# Access Compliance Report

## Public Rights-of-Way

### (Curb Ramps)

Intersection ID: 11910	Main Street: E_W_T_HARRIS_BV	Cross Street: ROBINSON_CHURCH_RD	Location: NE
ADA ID: EB11B97CFA3A	Ramp Type: PerpDiag	Initial Pass/Fail: Fail	Overall Compliance: No
Severity Score: 26.25			
Codes/Mitigation Info/Possible Solution		Field Measurements/Component Compliance

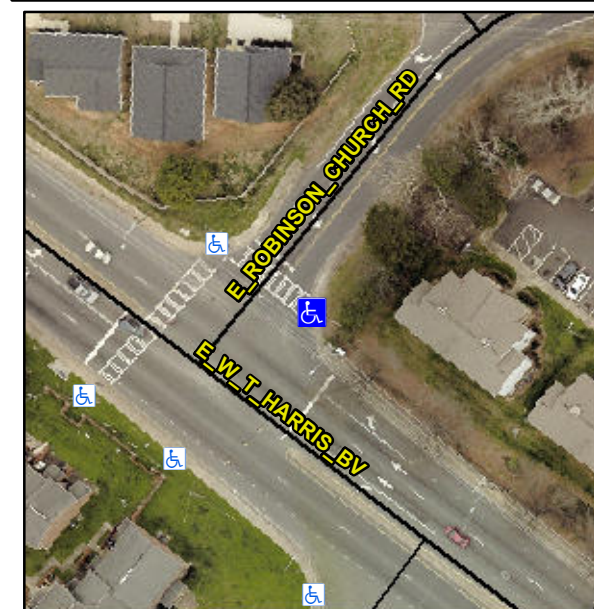
**Not Found, R304.2.2**

Compliance	Description	Data	Compliance	Description	Data
N/A	Ramp Length (in)	58.0	No	Ramp Slope (%)	12.8
Yes	Ramp Width (in)	48.0	Yes	Ramp XSlope (%)	3.4
N/A	Flare Type LT	N/A	N/A	Flare Type RT	N/A
N/A	Flare Slope LT (%)	N/A	N/A	Flare Slope RT (%)	N/A
N/A	Flare Traversable LT?	N/A	N/A	Flare Traversable RT?	N/A
N/A	Landing Length (in)	N/A	N/A	DWS Provided?	N/A
N/A	Landing Width (in)	N/A	N/A	DWS Contrast?	N/A
N/A	Landing Slope (%)	N/A	N/A	DWS Length (in)	N/A
N/A	Landing X Slope (%)	N/A	N/A	DWS Full Width?	N/A
N/A	Landing Curb? (Y/N)	N/A	N/A	DWS Offset (in)	N/A
N/A	Shared Landing?	N/A			
N/A	Gutter Ponding?	N/A	N/A	Gutter Slope (%)	N/A
N/A	Gutter Lip Ht (in)	0.5	N/A	Gutter X Slope (%)	N/A
N/A	Painted X Walk1?	Yes	N/A	Painted X Walk2?	No
	X Walk 1 Direction	To NW		X Walk 2 Direction	To SW
N/A	X Walk 1 Width (in)	117.0	N/A	X Walk 2 Width (in)	N/A
	X Walk 1 Slope (%)	2.8		X Walk 2 Slope (%)	6.0
	X Walk 1 X Slope (%)	6.6		X Walk 2 X Slope (%)	0.6

**Remove & Replace Curb Ramp With Two New Directional Ramps or Equivalent.**
